**AGENDA**  
**REGULAR MEETING OF THE**  
**WINDSOR HEIGHTS**  
**PLANNING AND ZONING COMMISSION**  
**Wednesday, May 22, 2024 - 5:30 PM**  
**WINDSOR HEIGHTS COUNCIL CHAMBERS - 1133 66th ST**  
**ZOOM: <https://us02web.zoom.us/j/7832856334>**  
**Meeting ID: 783 285 6334**

Date: May 22, 2024  
To: Windsor Heights Planning and Zoning Commission  
From: Trey Rouse  
Subject: Site Plan: University Avenue and 63<sup>rd</sup> Street Corner

**Motion to recommend for approval of the 1148 63<sup>rd</sup> Street Site Plan (The Windsor Apartments) with the conditions of approval laid out by City Staff to the City Council.**

# WINDSOR APARTMENTS - GEOMETRIC PLAN

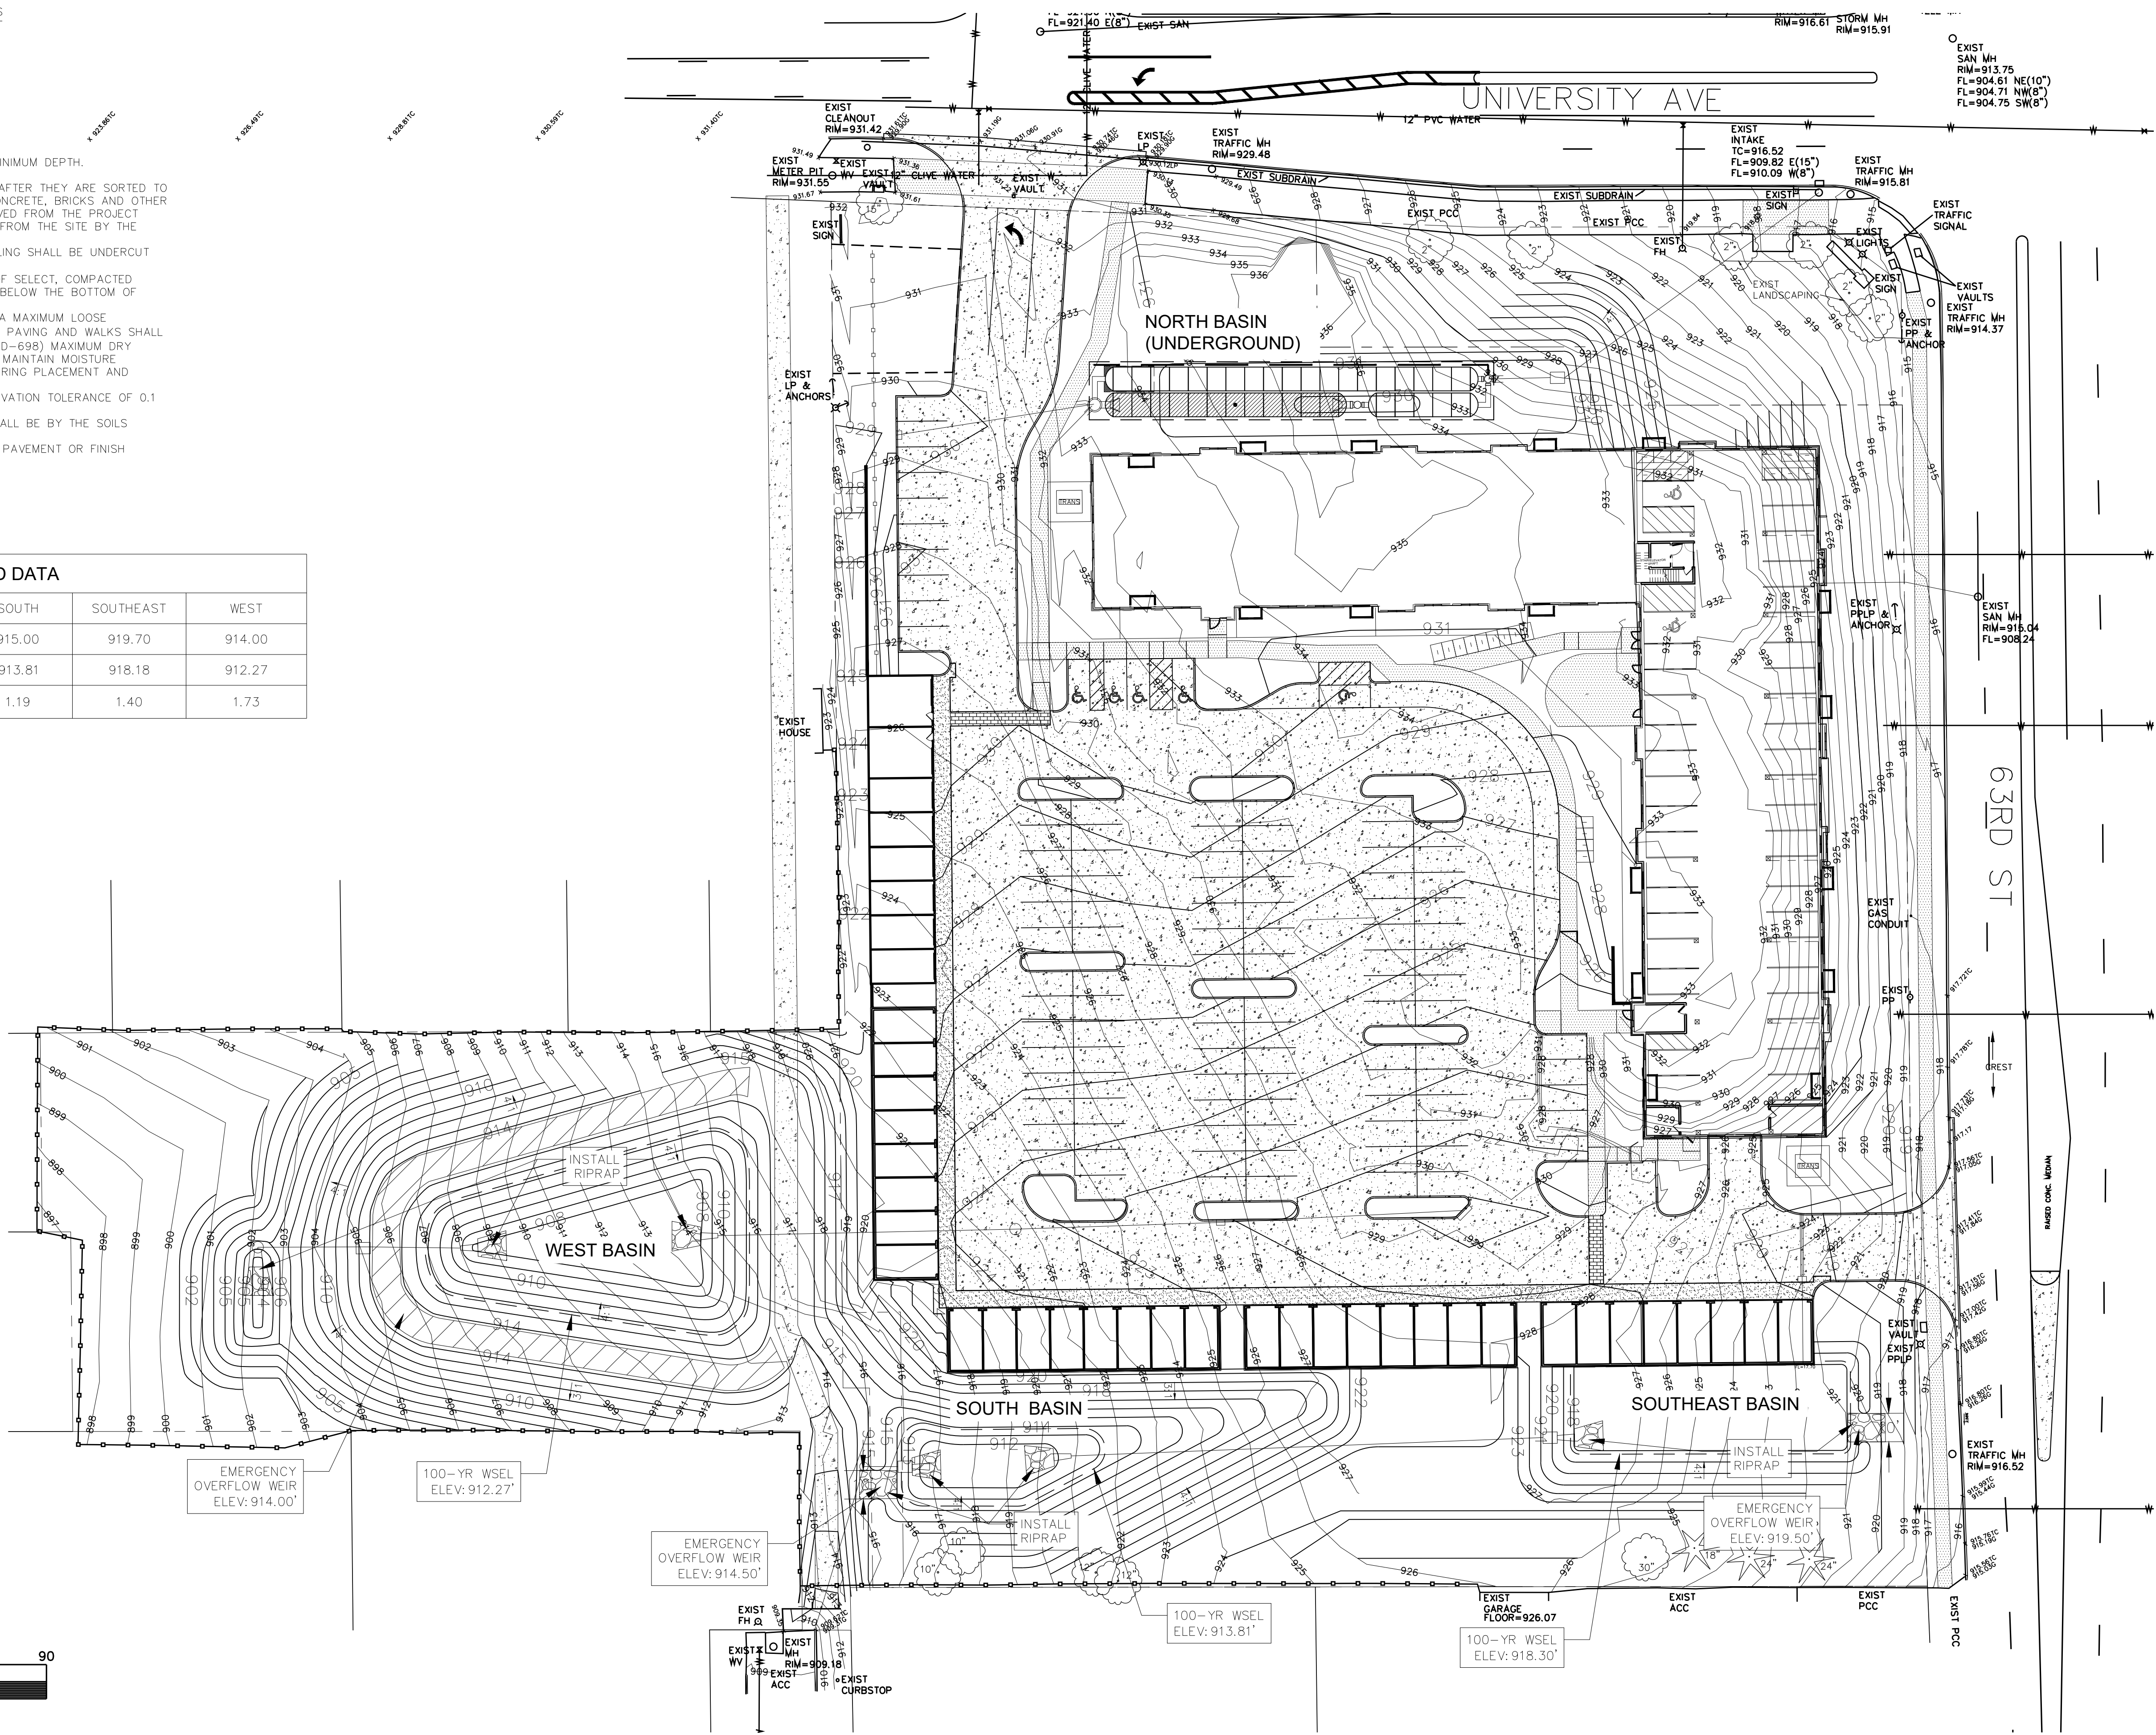
1. University Avenue Access (page 9)
  - a. As shown on the 4/15/24 site plan, the proposed driveway aligned with 64<sup>th</sup> Street on University is within the functional area of the intersection of 63<sup>rd</sup>/University. Queues are anticipated and have been observed to block this driveway in the peak hours. Per the report, the delay for residents leaving the apartment is LOS F. Creating a westbound left turn lane on University for the apartments will limit the ability to extend the eastbound left turn lane at 63<sup>rd</sup> street which is already a heavy movement.

- i. It is encouraged that the developer work with adjacent property owners to move the full access driveway further west away from the intersection of 63<sup>rd</sup> Street. Note: Both city staff and/or the developer have reached out in person, letter, and phone to the owner of 6412 University Avenue to discuss options and received no response from the property owner.

If Planning and Zoning chooses to recommend allowing the proposed full access on University Avenue, the City Administration recommends it be a temporary full access and a condition on the site plan approval. A temporary full-access shall be allowed on to University Ave as shown in the site plan. Said access shall be limited to a duration of five years from the date an occupancy certificate is issued for any structure built, after which time the City Council must review the access to determine if the temporary full-access may continue or otherwise terminated and converted to a right-in-right-out only access. Temporary full access may also be terminated prior to five years as directed by the Council if they so determine said access has contributed to additional traffic conflicts/accidents or if roadway improvements are determined necessary. When temporary full-access is terminated, any action needed to discourage use as a full-access shall be a cost of the developer.

WINDSOR APARTMENTS - LANDSCAPING PLAN

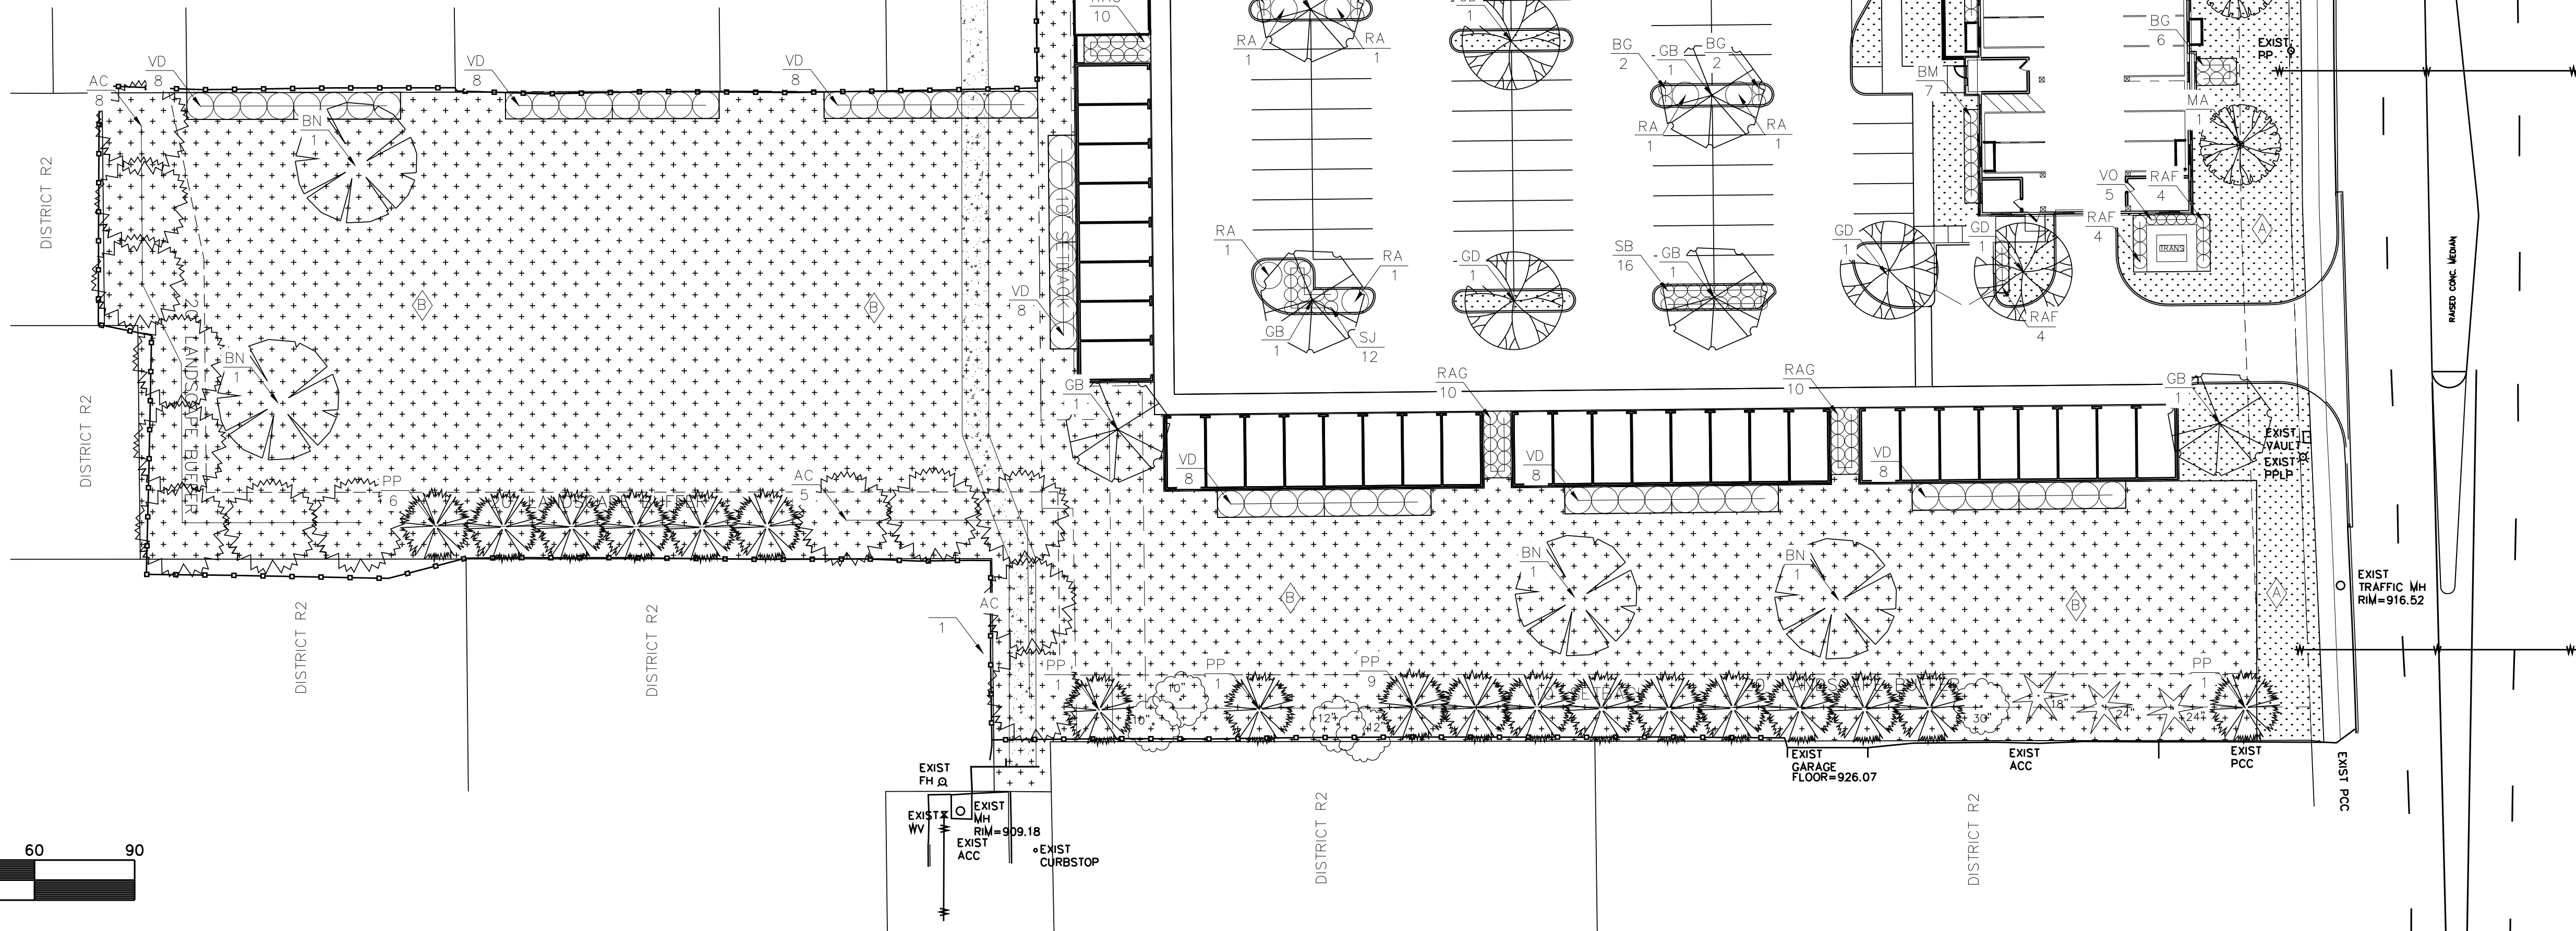
The applicant has provided a landscaping plan within the site plan (sheet 14) to illustrate the planting locations and types of plantings that will be on the development. The plantings provided and shown meet the requirements of the landscaping requirements by numbers and utilize plants on the approved Windsor Heights Tree/Plant list. The required number of trees and shrubs based upon the size of development are 58 trees (1/2000 sq. ft. of pervious area) and 286 shrubs (5/2000 sq. ft. of pervious area).

This requirement has been met as the applicant shows in the site plan to be providing 62 trees in total (utilizing 16 existing trees) and 299 shrubs.
